Riverview House, Uxbridge

Class AA Upward Extension Application

Project Title:	Riverview House, Uxbridge
Project Ref:	1153
Report Title:	Class AA Upward Extension Application
Report Ref:	P932
Revision:	0
Date of Issue:	September 2022
Purpose of Issue:	Information
Compiled By:	Beatriz Antuna Tentor
Reviewed By:	Ben Paterson
Review Date:	12-09-22
File Location:	-

Proposed Amened Plan REF : 1153-P133-0_GA PROPOSED THIRD FLOOR PLAN

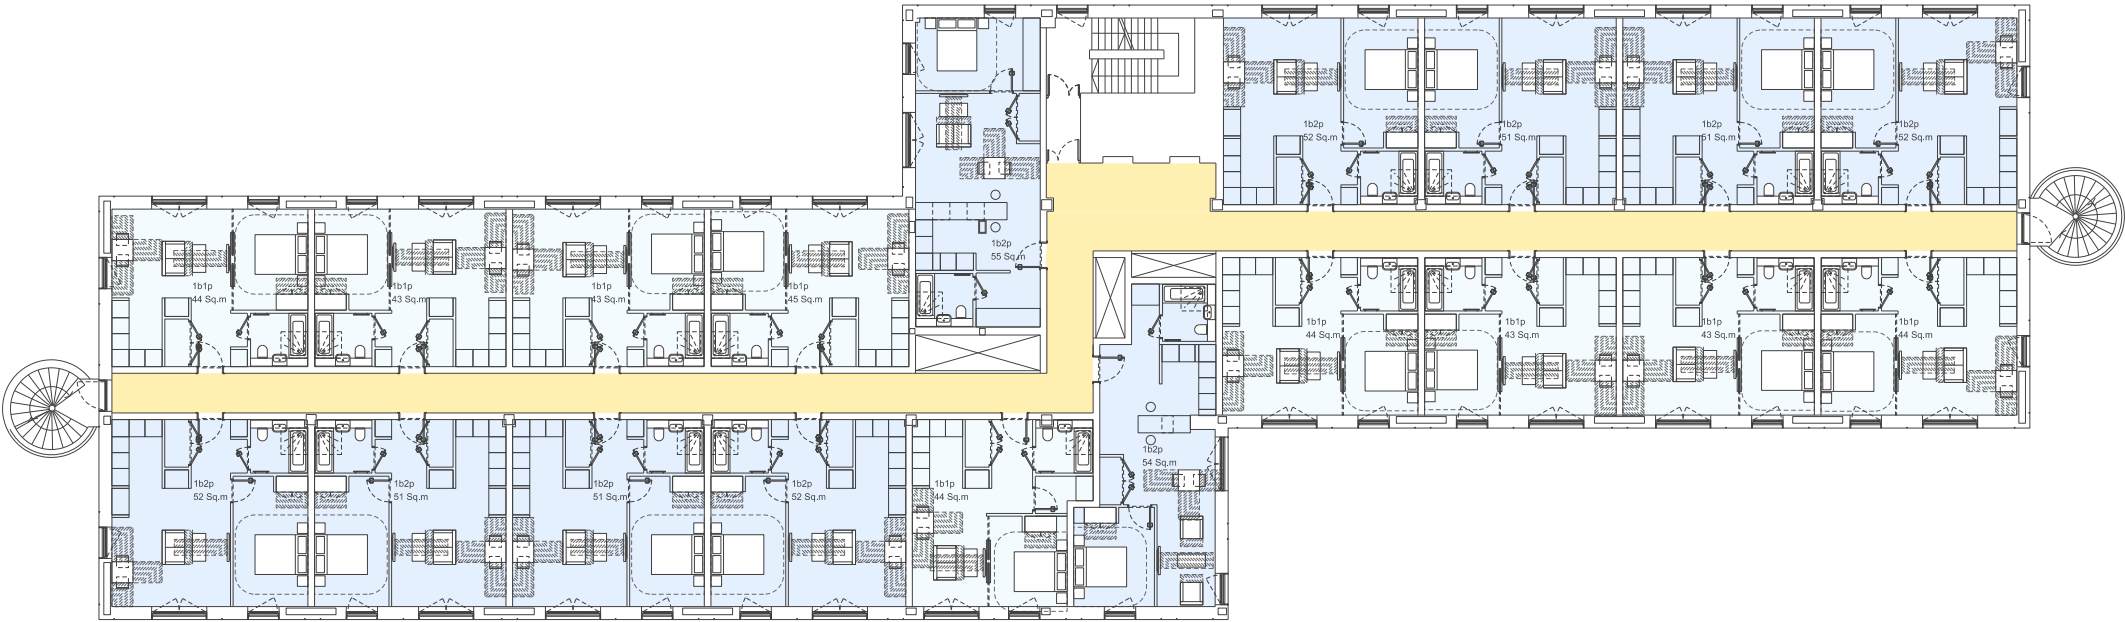
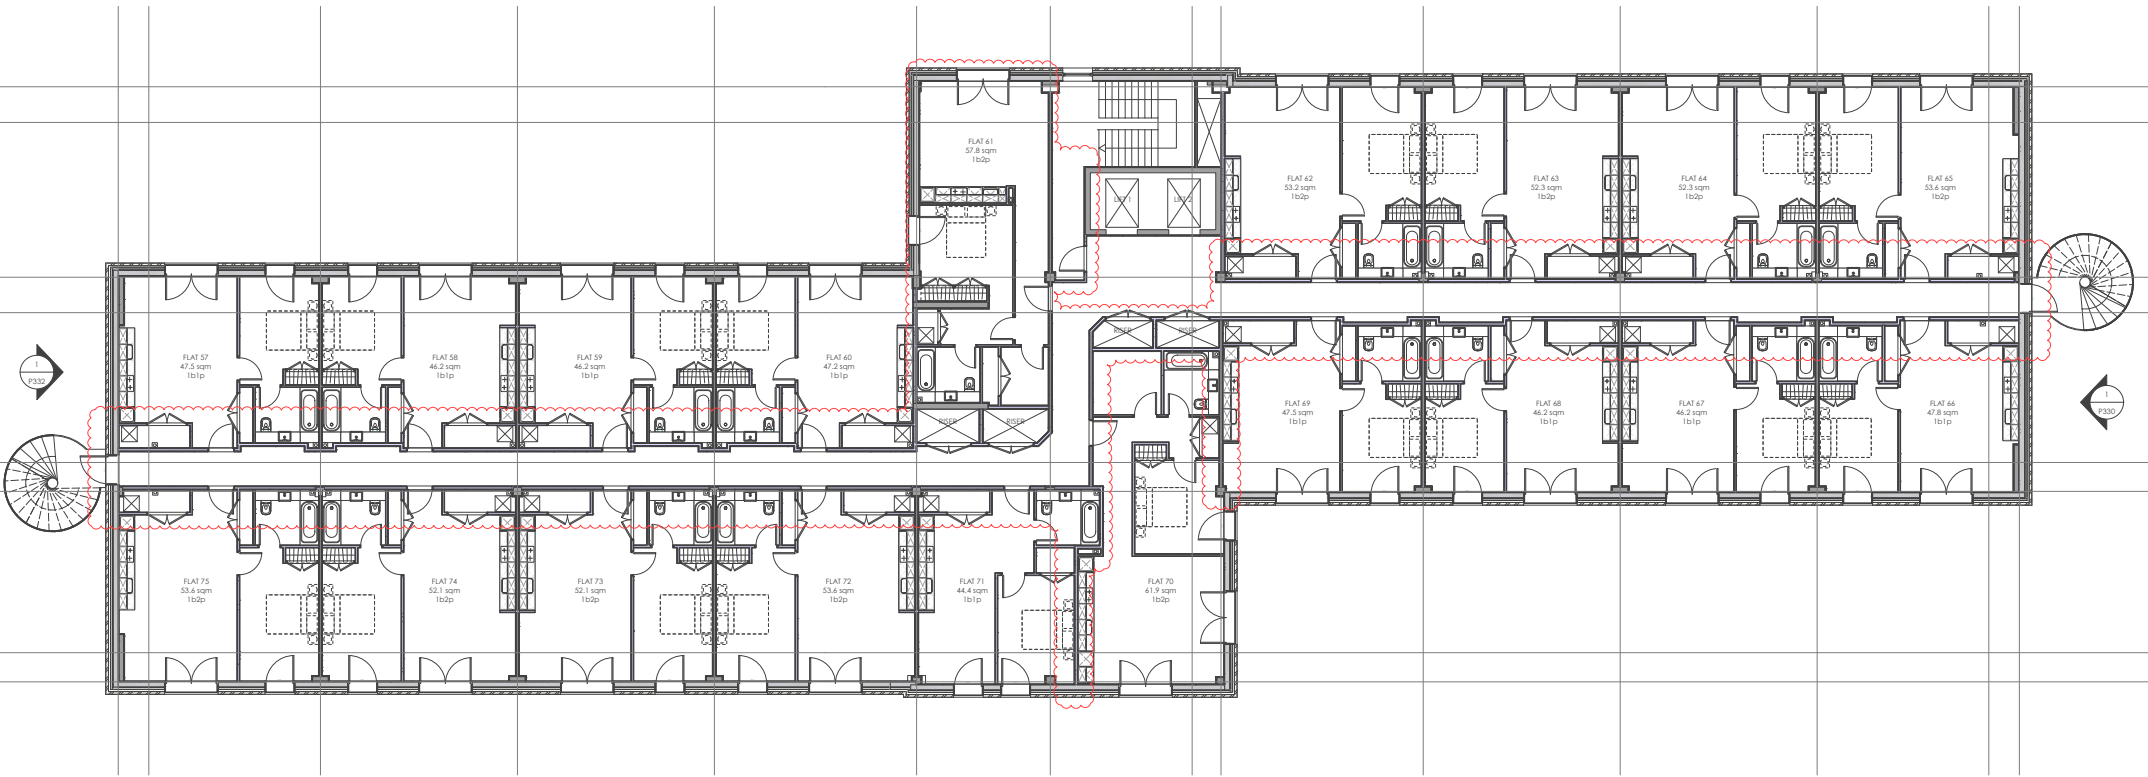
- The arrangement of apartments on the fourth floor is consistent with the consented scheme where the predominant changes occur along the internal wall of apartments where the width of the corridor has narrowed slightly to allow for generally 1200mm clear wall-to-wall, with passing spaces 1500mm in width. The naming conventions of the individual apartments is consistent with the NDSS and the previous application.

- Minor internal modifications of apartments to create improved, more open plan living accommodation, with better access to storage.
- Rationalised arrangement of bathrooms and coordination of services between the ground and fourth floors.

- Modification of Apartment 61 (left-hand side of the stair core) owing to the continuation of the structures from the floors below.
- Modification of risers from advise from the MEP consultant.

- Modification of the internal layout of apartment 70, following changes to the arrangement of the service risers.

Proposed Amened Plan REF: 1153-P134-0_GA PROPOSED FOURTH FLOOR PLAN

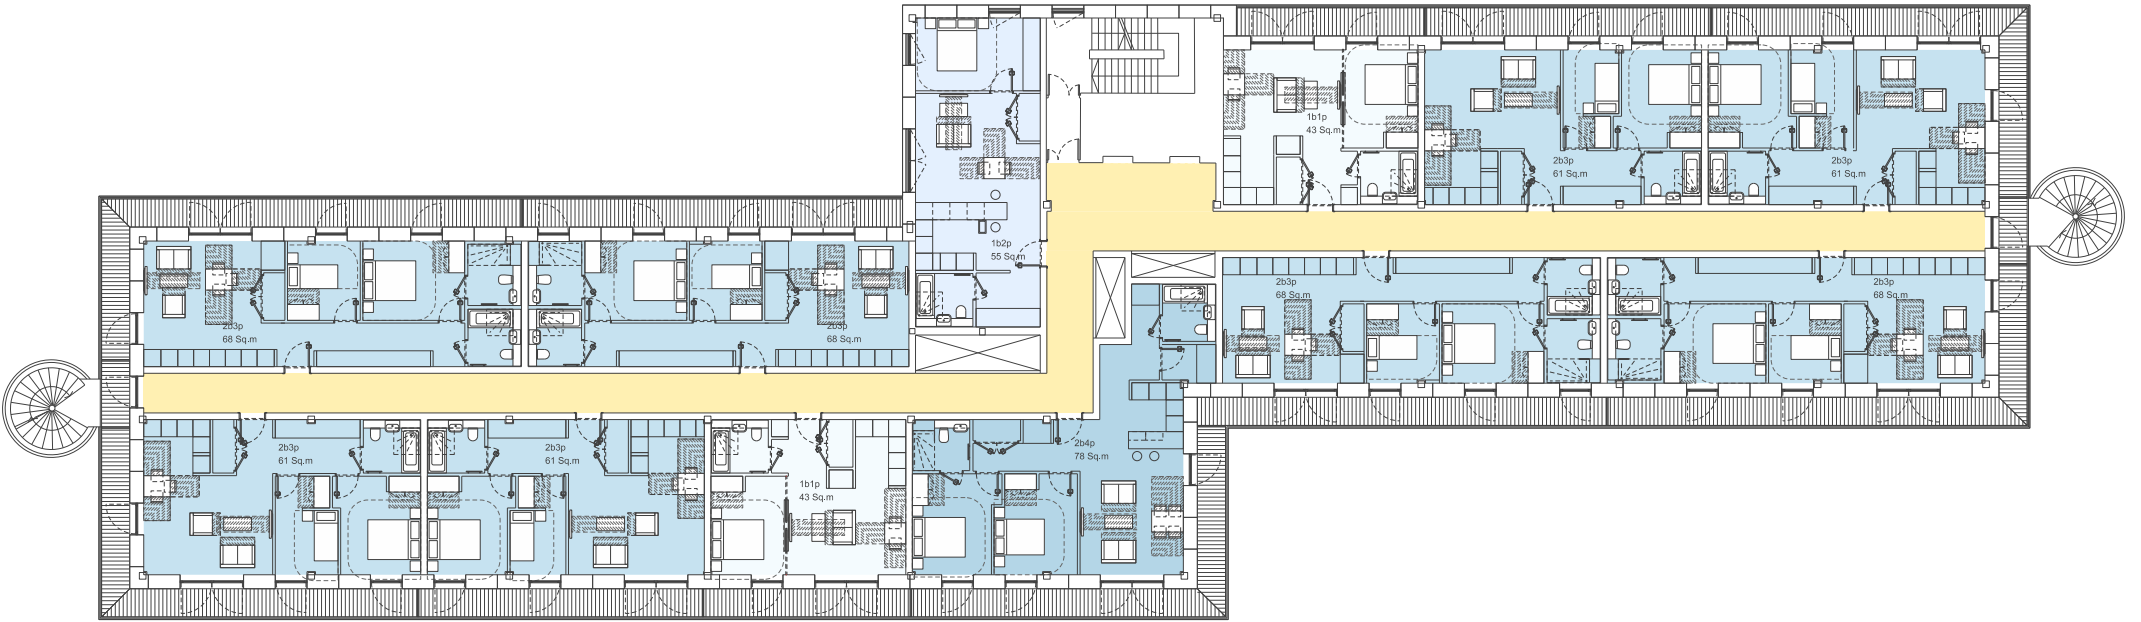
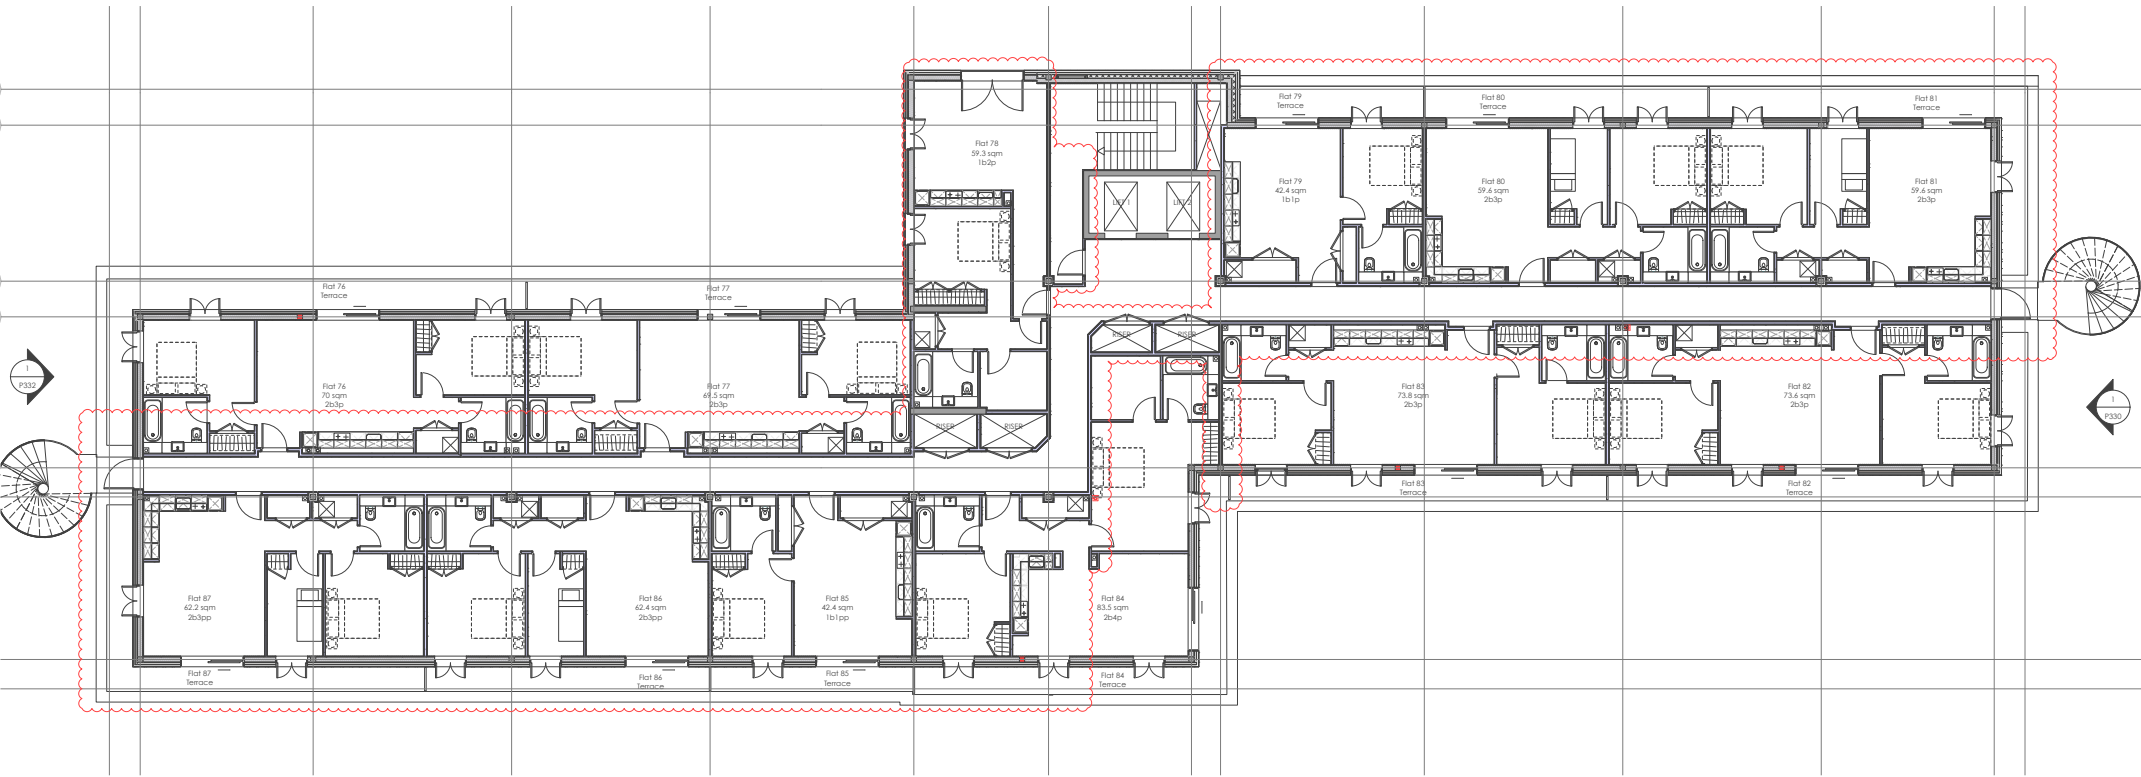
- Parapet increased in depth from what appears to be 100mm for buildability purposes.
- Changes occur along the internal wall of apartments where the width of the corridor has narrowed slightly to allow for generally 1200mm clear wall-to-wall, with passing spaces 1500mm in width. The naming conventions of the individual apartments is consistent with the NDSS and the previous application.

- Changes in the internal arrangement of the 2b3p apartments to the north side of the west wing and to the south side of the east wing. The primary drivers for changes included the alignment of services with the floors below, creating a more modern arrangement of bedrooms and bathrooms either side of the central living space.

- Modification of Apartment 78 (left-hand side of the stair core) owing to the continuation of the structures from the floors below.
- Revised riser positions and sizes following MEP advice.

- Changes in the arrangement of the consented fenestration, where once the depth of the proposed parapet has been included, sliding doors and smaller Juliet balcony doors are more appropriate to provide access onto the terrace.

Proposed East Amended Elevation REF: 1153-P335-0_GA PROPOSED EAST ELEVATION

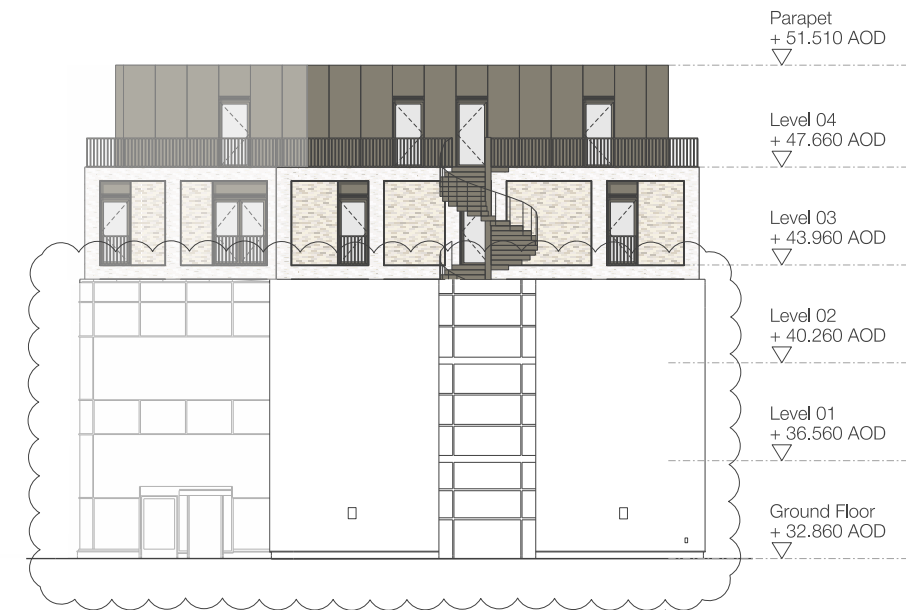
- The proposed and 'punctured' arrangement of the windows/ balcony doors and cream bricks seeks to maintain the strong white horizontal and vertical banding established within the consented application.

- As a result of the existing levels and structure, modifications to the heights of windows/ balcony doors have been made when compared with the consented scheme.

- These existing constraints result in a slight adjustment to the vertical and horizontal white brick grid with a slight variation in which the two outermost vertical brick piers becoming 4 bricks wide where all horizontals are now 11 bricks high with exception of the course between ground and first floor which is 9.

- The Consented Approach of achieving the contrast between the white and cream bricks is no longer provided by the "25mm wide metal profile" but by recessed cream bricks which exaggerate the impression of a punctured facade. The decision to approach this in a different manner has been informed by buildability issues this detail would present in addition to a lack of built examples. Moreover the detail, particularly at the head condition would have presented issues with maintenance where the cream bricks would have become stained being set within the same plane as the white bricks above.

- Highlighted adjacent and in red are the areas of the facade where the arrangement of windows has been modified to suite the replanning of internal apartments and the position of existing structures. To the fourth floor the unsuitable handrail detail as consented has been substituted for a parapet with a recessed handrail behind. In addition on this floor large balcony doors have been substituted for a sliding door, where the large single glazed doors are now juliet balcony doors owing to the reduced size of the terrace compared with the consented scheme.

Proposed North Amended Elevation REF: 1153-P337-0_GA PROPOSED WEST ELEVATION

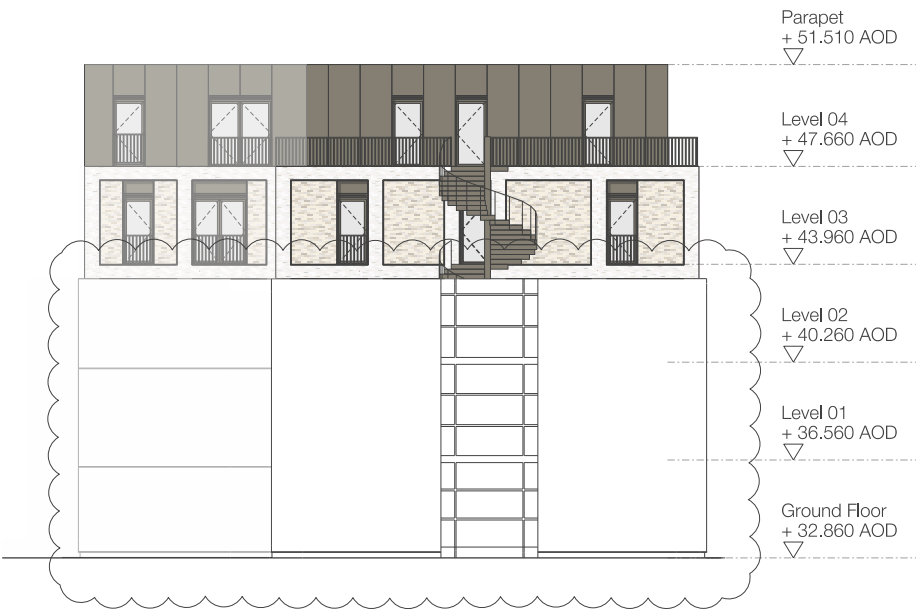
- As a result of the existing levels and structure, modifications to the heights of windows/ balcony doors have been made when compared with the consented scheme.

- These existing constraints result in a slight adjustment to the vertical and horizontal white brick grid with a slight variation in which the two outermost vertical brick piers becoming 4 bricks wide where all horizontals are now 11 bricks high with exception of the course between ground and first floor which is 9.

- The Consented Approach of achieving the contrast between the white and cream bricks is no longer provided by the "25mm wide metal profile" but by recessed cream bricks which exaggerate the impression of a punctured facade. The decision to approach this in a different manner has been informed by buildability issues this detail would present in addition to a lack of built examples. Moreover the detail, particularly at the head condition would have presented issues with maintenance where the cream bricks would have become stained being set within the same plane as the white bricks above.

- Highlighted adjacent and in red are the areas of the facade where the arrangement of windows has been modified to suite the replanning of internal apartments and the position of existing structures. To the fourth floor the unsuitable handrail detail as consented has been substituted for a parapet with a recessed handrail behind. In addition on this floor large balcony doors have been substituted for a sliding door, where the large single glazed doors are now Juliet balcony doors owing to the reduced size of the terrace compared with the consented scheme.

Proposed North Amened Elevation REF: 1153-P336-0_GA PROPOSED SOUTH ELEVATION

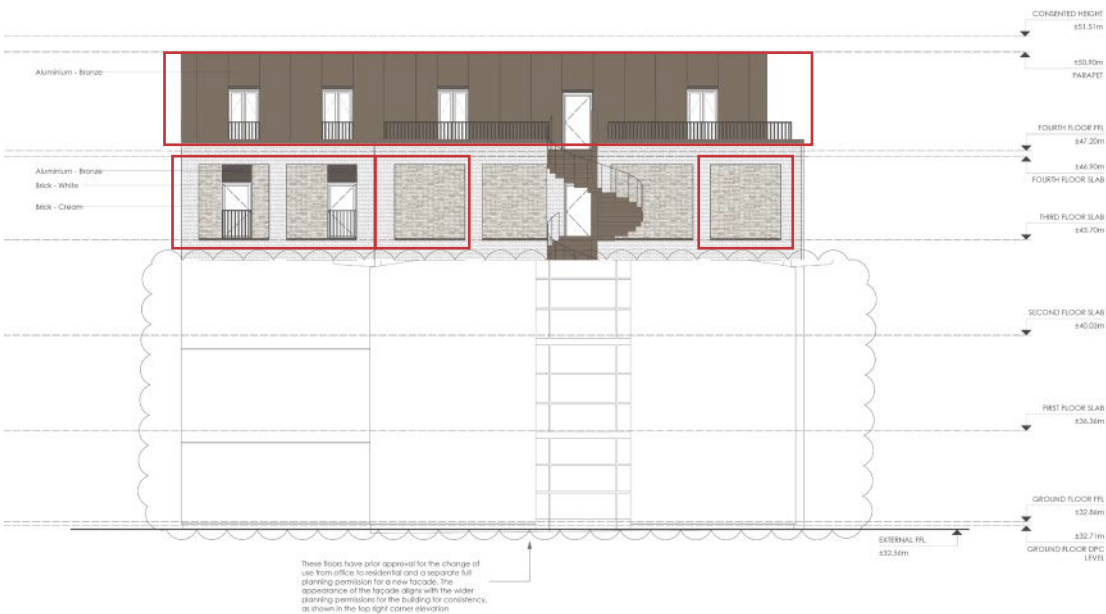
- As a result of the existing levels and structure, modifications to the heights of windows/ balcony doors have been made when compared with the consented scheme.

- These existing constraints result in a slight adjustment to the vertical and horizontal white brick grid with a slight variation in which the two outermost vertical brick piers becoming 4 bricks wide where all horizontals are now 11 bricks high with exception of the course between ground and first floor which is 9.

- The Consented Approach of achieving the contrast between the white and cream bricks is no longer provided by the “25mm wide metal profile” but by recessed cream bricks which exaggerate the impression of a punctured facade. The decision to approach this in a different manner has been informed by buildability issues this detail would present in addition to a lack of built examples. Moreover the detail, particularly at the head condition would have presented issues with maintenance where the cream bricks would have become stained being set within the same plane as the white bricks above.

- Highlighted adjacent and in red are the areas of the facade where the arrangement of windows has been modified to suite the replanning of internal apartments and the position of existing structures. To the fourth floor the unsuitable handrail detail as consented has been substituted for a parapet with a recessed handrail behind. In addition on this floor large balcony doors have been substituted for a sliding door, where the large single glazed doors are now Juliet balcony doors owing to the reduced size of the terrace compared with the consented scheme.
